Technical Service Bulletin: TSB180091

New Camshaft Thrust Bearings

Figure 1, New Cam Thrust Bearing.

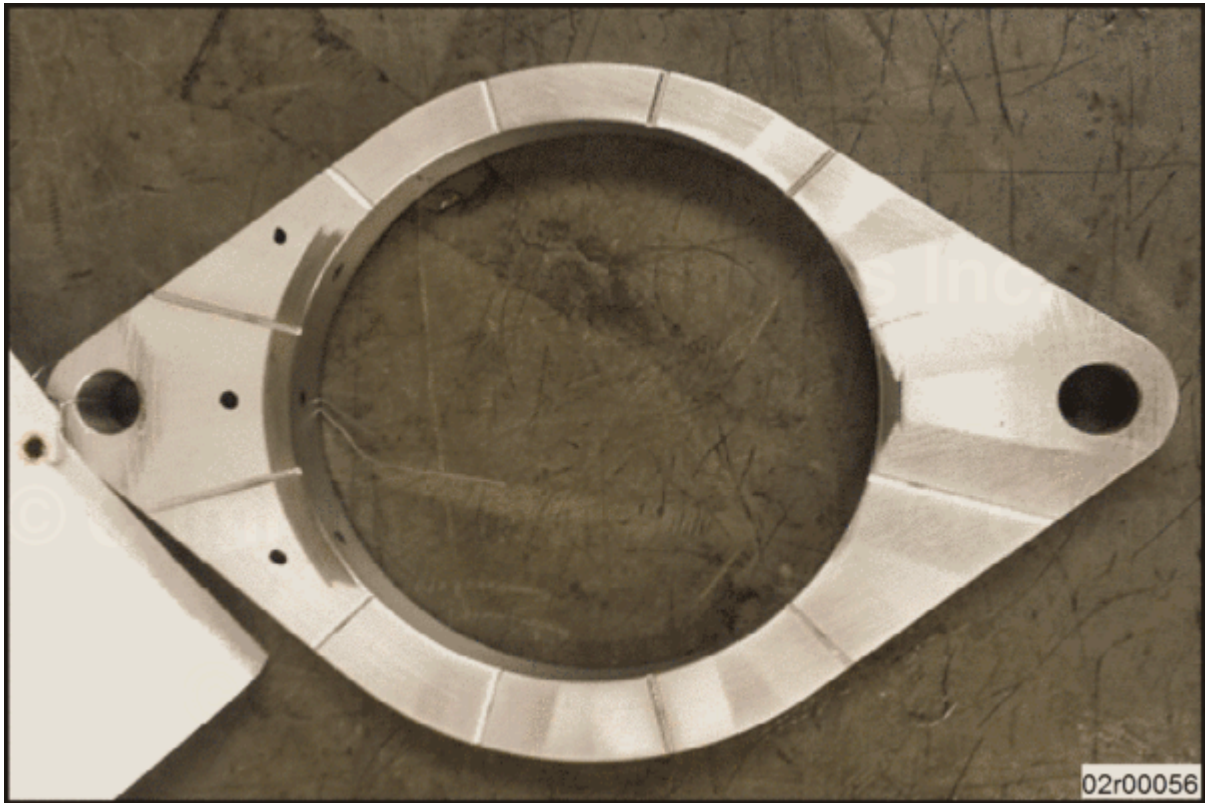
New camshaft thrust bearing is made from a more robust material. New camshaft thrust bearing also incorporates a ramp and pad design on the thrust surface, creating an oil film between camshaft thrust bearing and camshaft.

New part has 12 oil grooves, existing part has 6 oil grooves. See Figure 1.
